Points of Objection

Building a Battery Energy Storage System (BESS) next to a Site of Special Scientific Interest (SSSI) requires the careful consideration of several factors. SSSIs are designated to protect areas of significant ecological or geological importance, and any development nearby could potentially impact the local environment.

7. Fire / Fire Safety

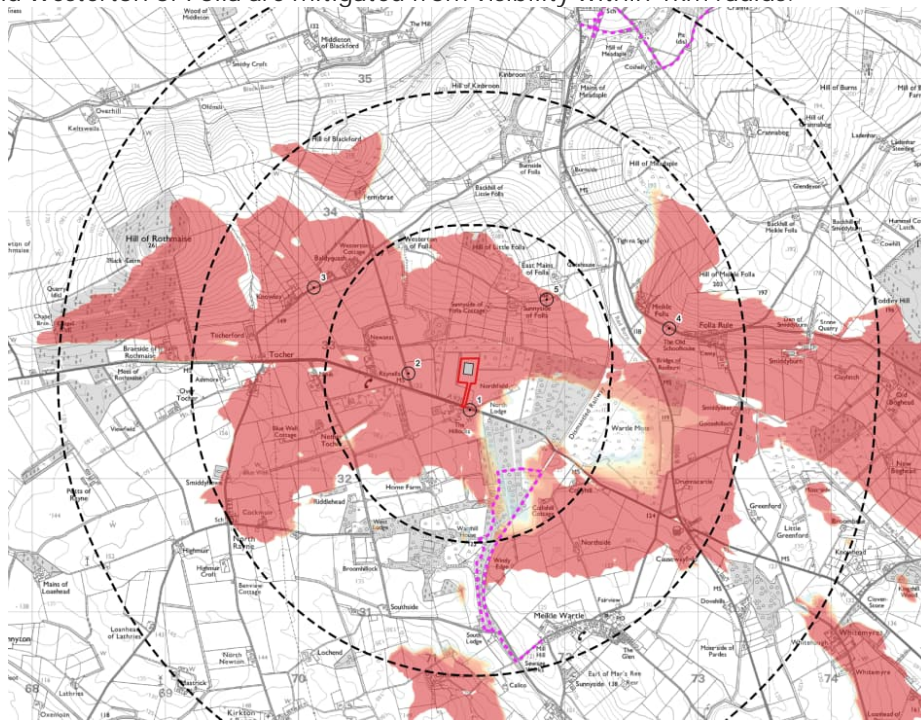
The risks of fire associated with a Battery Energy Storage System (BESS) located near a Site of Special Scientific Interest (SSSI) include:

- Fire Spread: In the event of a fire, there is a risk that flames could spread to the nearby SSSI, potentially damaging sensitive habitats and wildlife.

- Toxic Emissions: Fires involving batteries can release toxic gases and particulates, which could adversely affect air quality and harm any living organisms within the SSSI.

- Thermal Runaway: Lithium-ion batteries, commonly used in BESS, can experience thermal runaway, leading to overheating and potential fires. If a fire occurs, it may be difficult to control, especially if it spreads to surrounding vegetation.

- Environmental Contamination: Fire suppression efforts may involve the use of chemicals that could contaminate soil and water sources in the SSSI, impacting local ecosystems.

- Increased Fire Risk: The presence of electrical equipment and batteries can increase the overall fire risk in the area, particularly in dry conditions or during periods of high temperatures.

- Impact on Emergency Response: If a fire occurs, the proximity to the SSSI may complicate emergency response efforts, making it more challenging to contain the fire and protect both the BESS and the surrounding environment.

While the site is planned to store water for emergency fire response, the planning application does not include risk assessment or consultation from emergency services. Additionally, conducting a thorough risk assessment and engaging with fire safety experts can help ensure that potential hazards are adequately addressed.
